To: T10 Technical Committee  
From: Rob Elliott, Compaq Computer Corporation (Robert.Elliott@compaq.com)  
Date: 23 September 2001  
Subject: SPI-4 negotiation message rewrite

The PPR, WDTR, and SDTR message descriptions are full of duplications and contain some errors. This proposal rewrites the three sections, moving most of the text into a model section in clause 4 and simplifying the individual sections in clause 16. It attempts to eliminate duplications and fix errors. It only attempts to change behavior that needs to be changed.

Figure 1. Error-free negotiation message sequences.

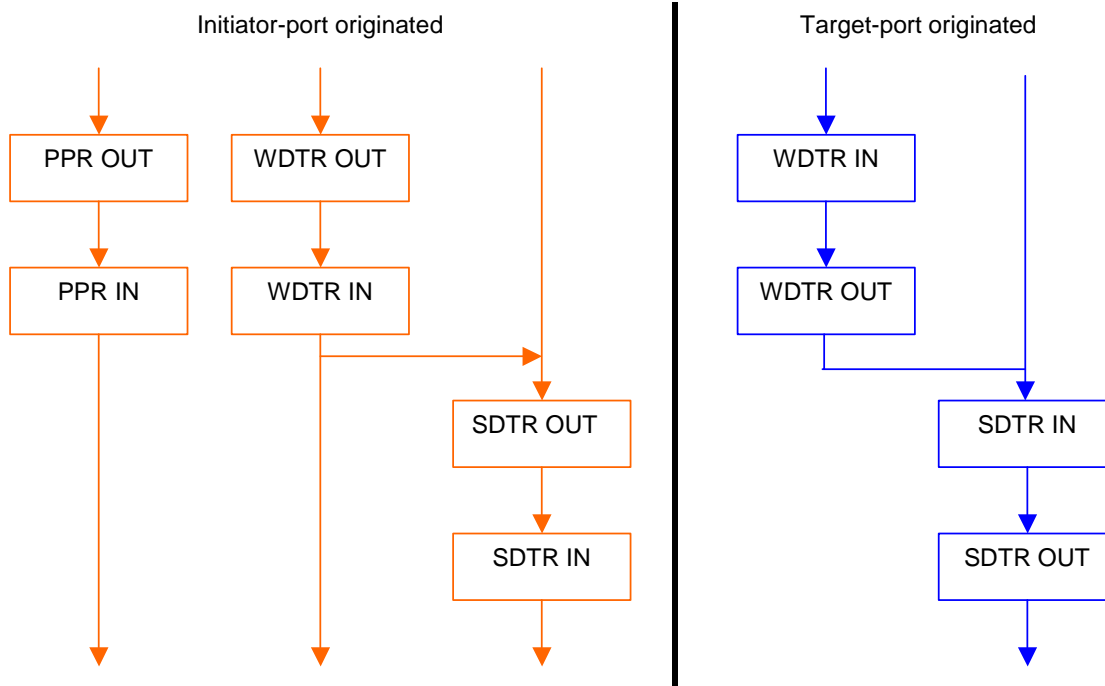
The valid error-free negotiation message sequences are shown in Figure 1. A description of the possible message sequences is in section 4.1.7.

Figure 2. Initiator originated PPR negotiation: initiator response

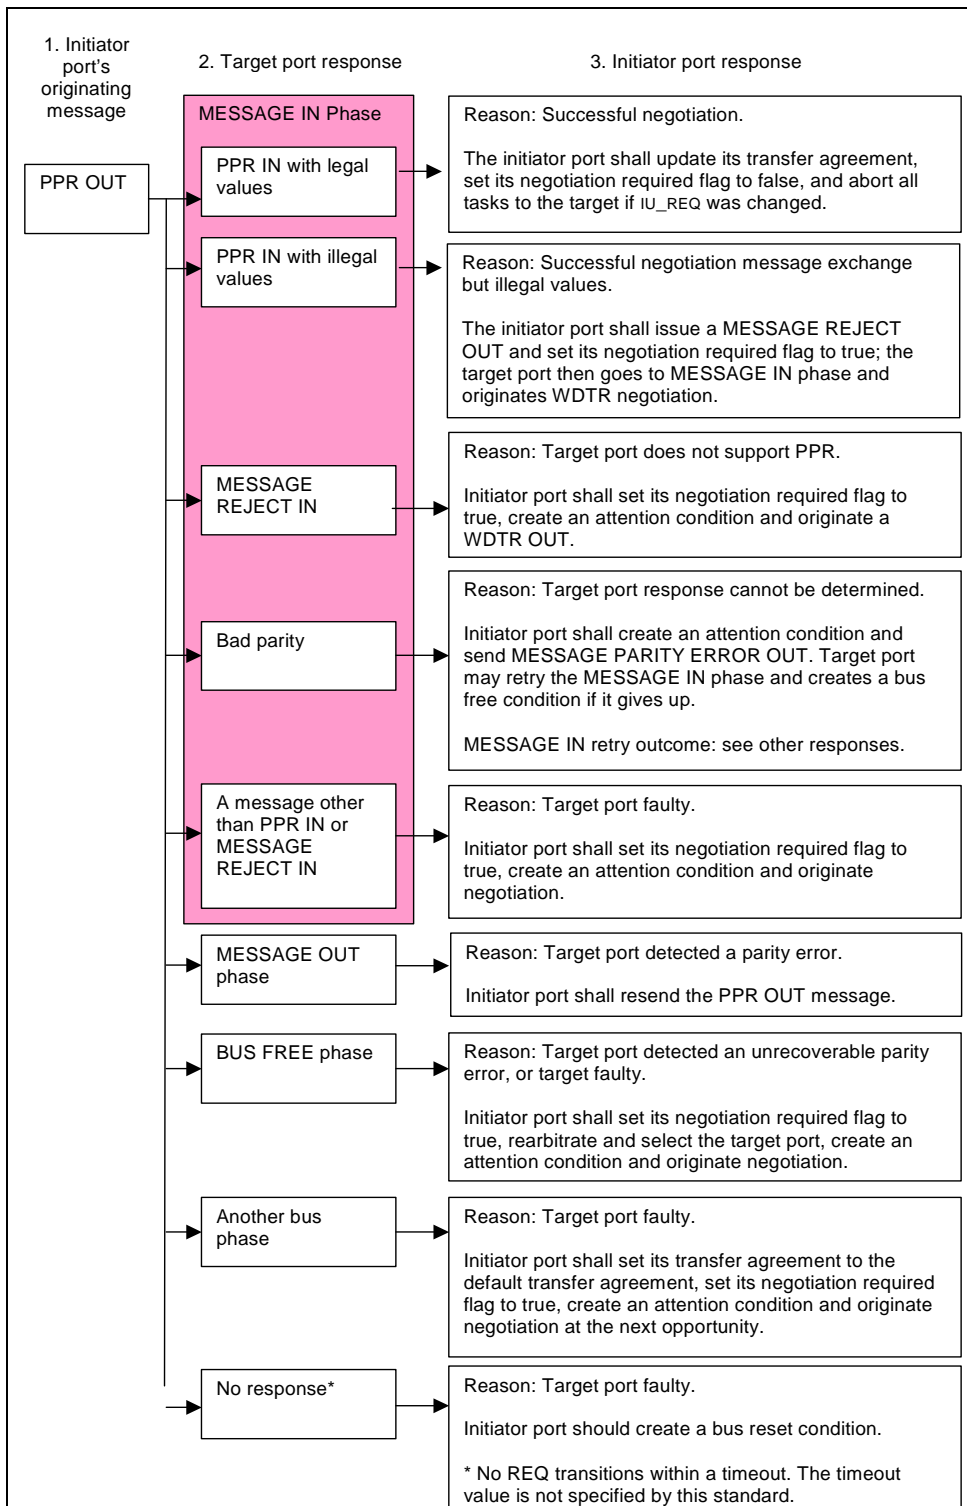
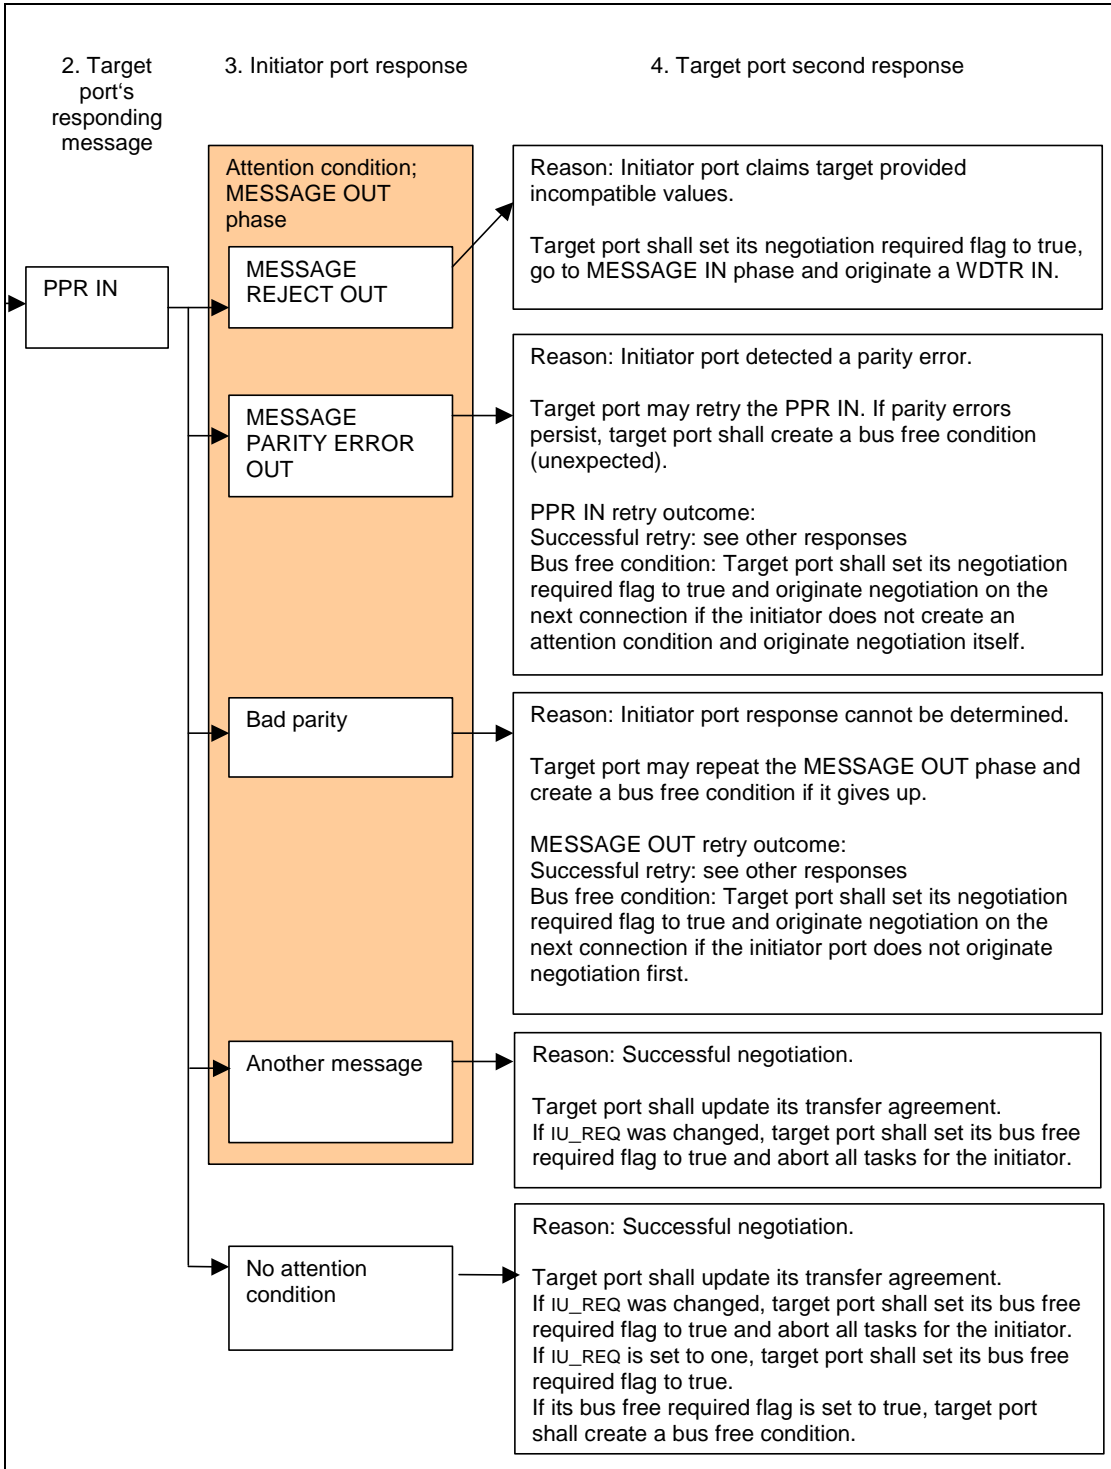
Figure 2 shows how the initiator port shall respond to various target port responses to an originating PPR OUT. The initiator port shall maintain the previous transfer agreement unless otherwise indicated.

Figure 3 shows how the target port shall respond to various initiator port responses to a responding PPR IN. The target port shall maintain the previous transfer agreement unless otherwise indicated.

Figure 4. Initiator originated WDTR negotiation: initiator response

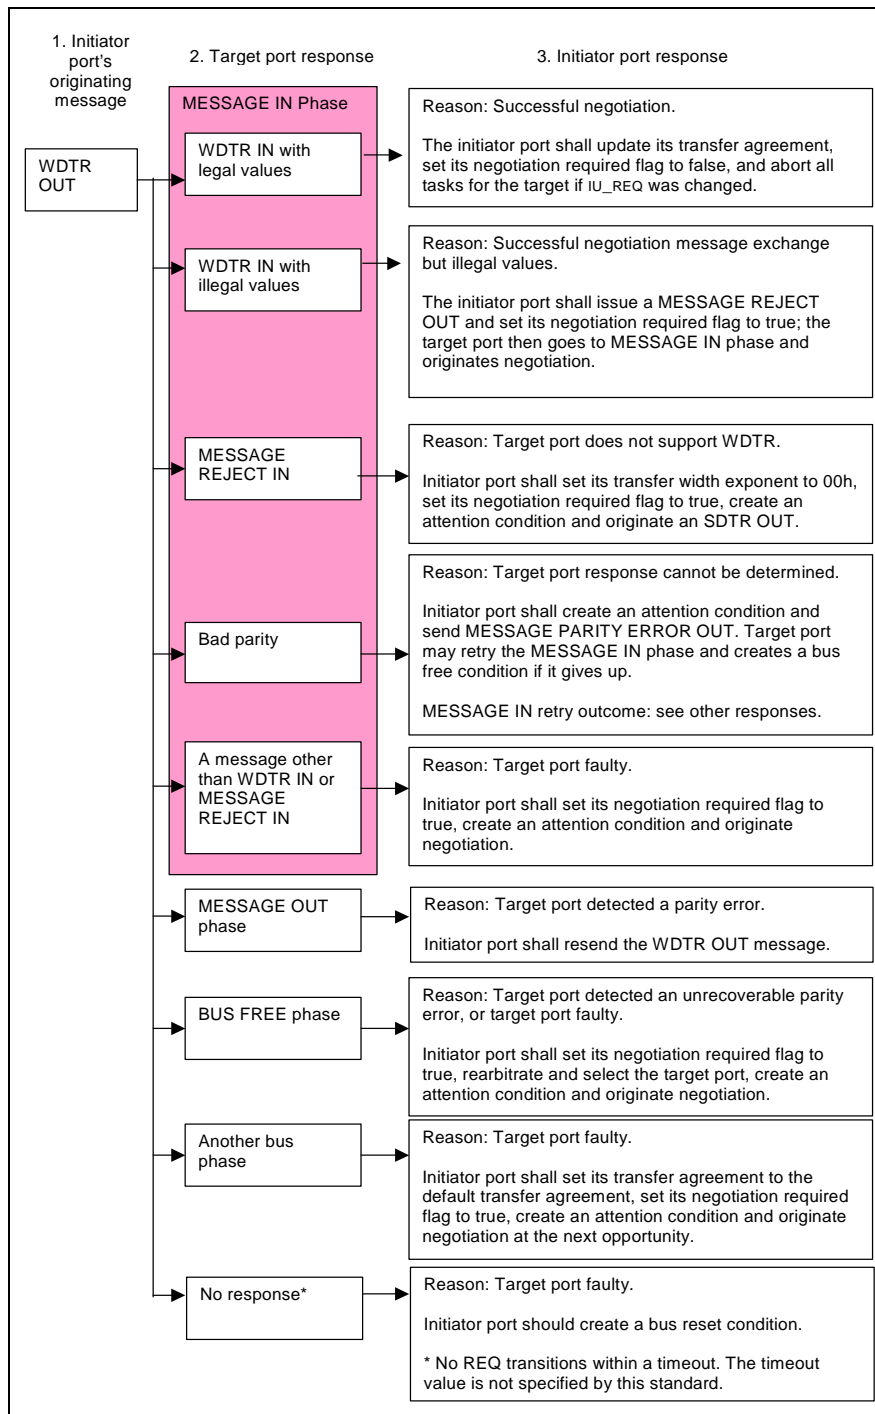
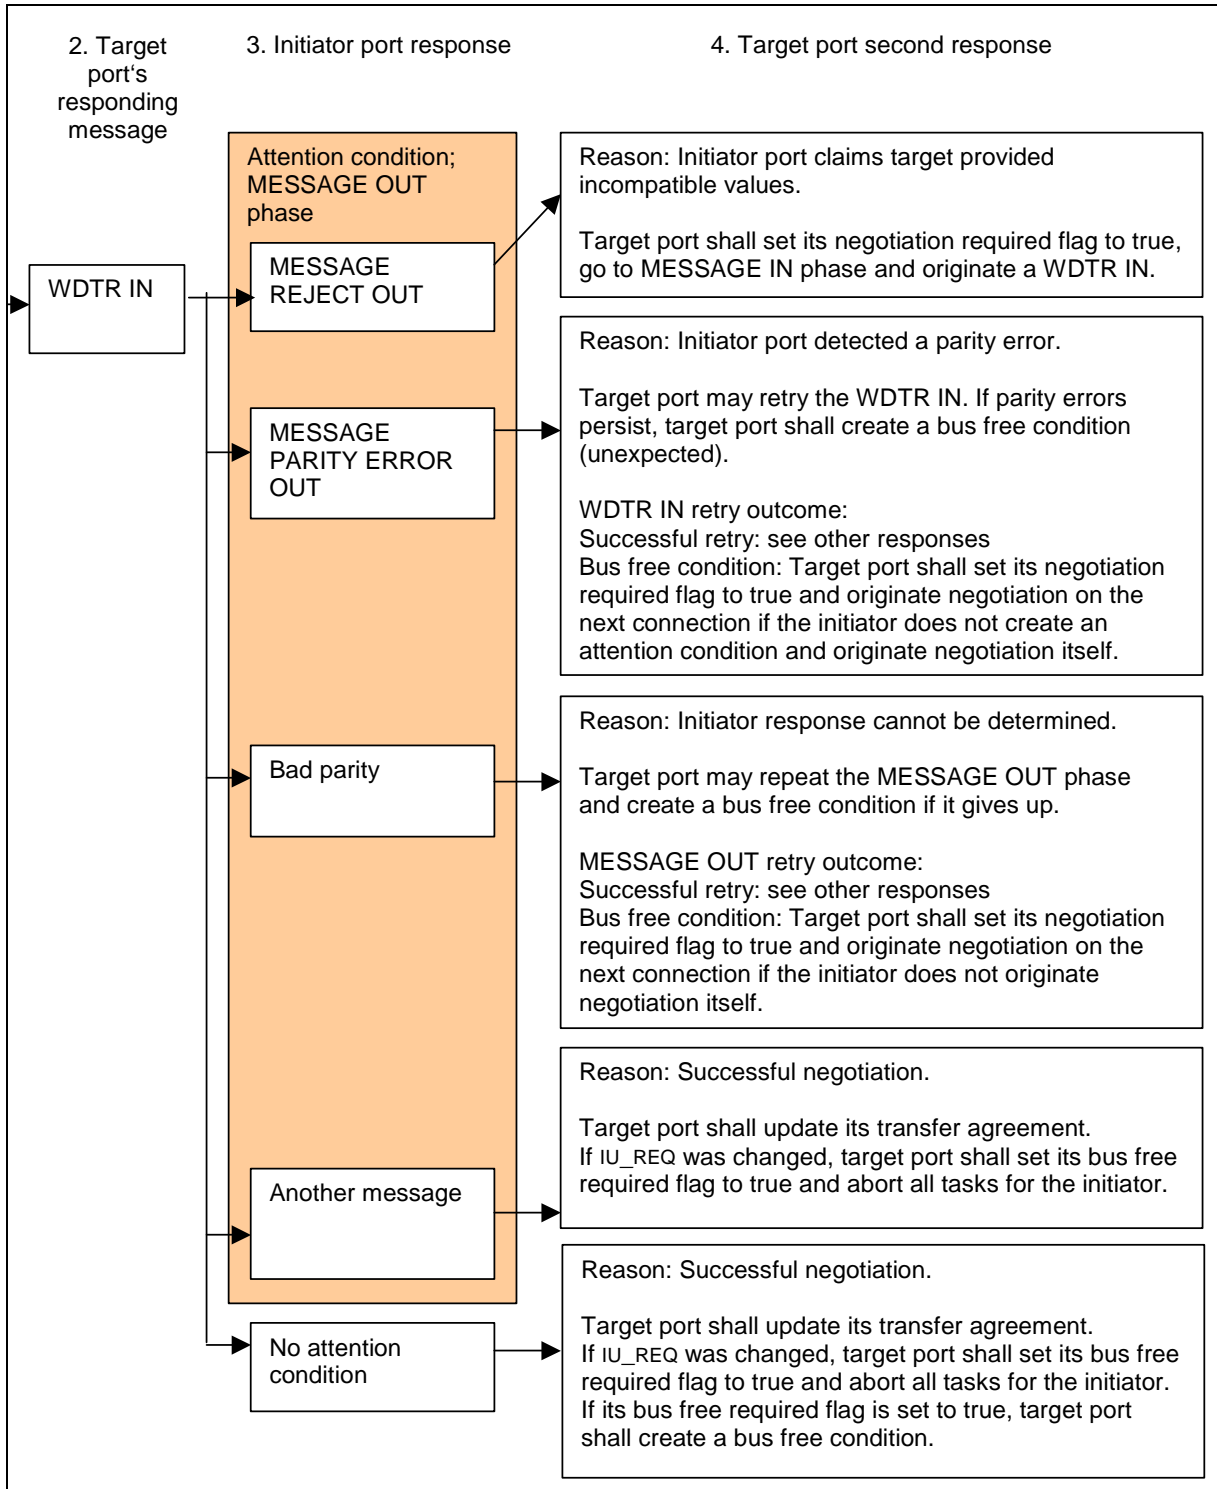
Figure 4 shows how the initiator port shall respond to various target port responses to an originating WDTR OUT. The initiator port shall maintain the previous transfer agreement unless otherwise indicated.

Figure 5 shows how the target port shall respond to various initiator port responses to a responding WDTR IN. The target port shall maintain the previous transfer agreement unless otherwise indicated.

Figure 6. Initiator originated SDTR negotiation: initiator response

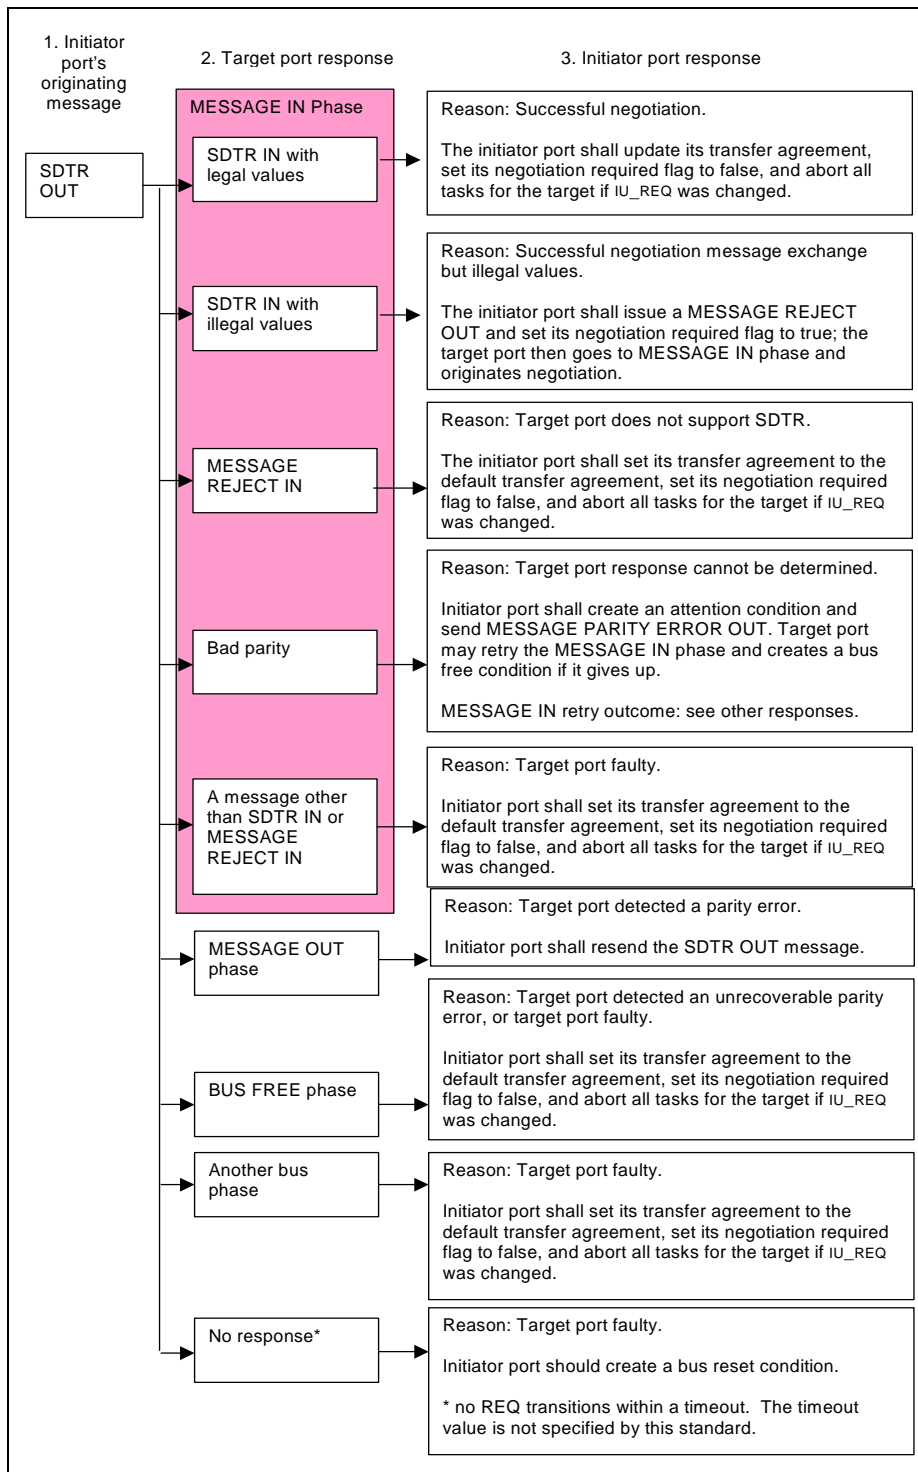
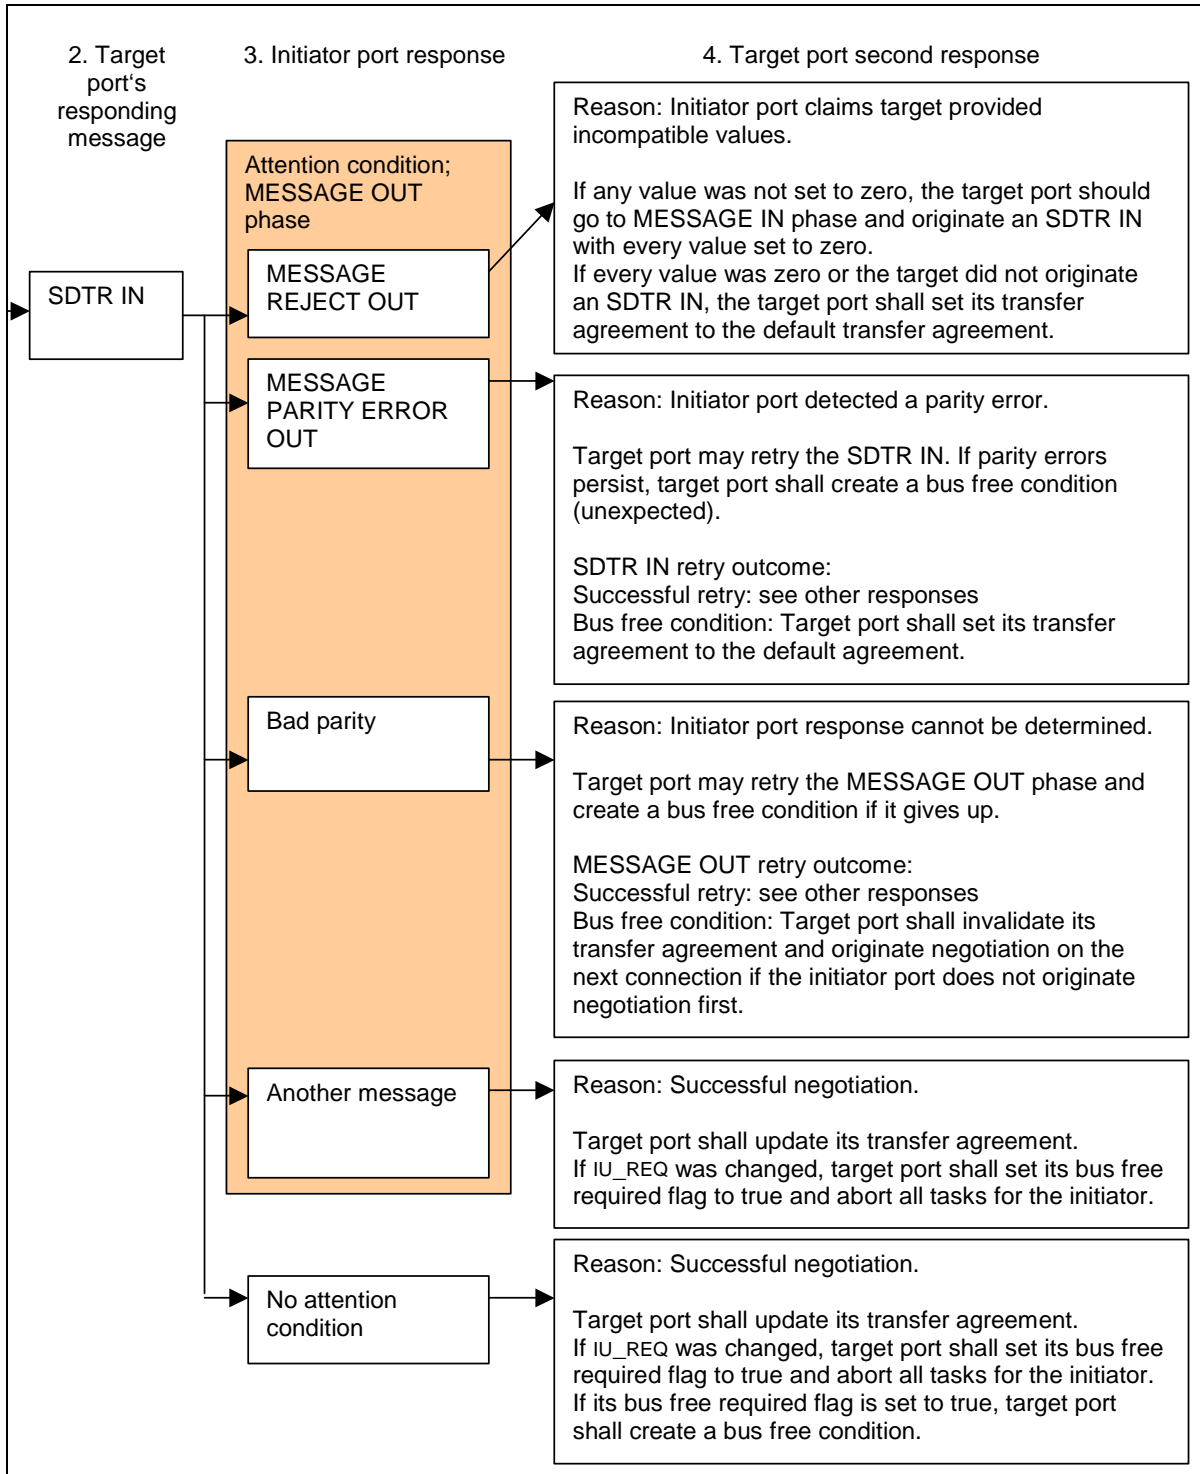
Figure 6 shows how the initiator port shall respond to various target port responses to an originating SDTR OUT. The initiator port shall maintain the previous transfer agreement unless otherwise indicated.

Figure 7 shows how the target port shall respond to various initiator port responses to a responding SDTR IN. The target port shall maintain the previous transfer agreement unless otherwise indicated.
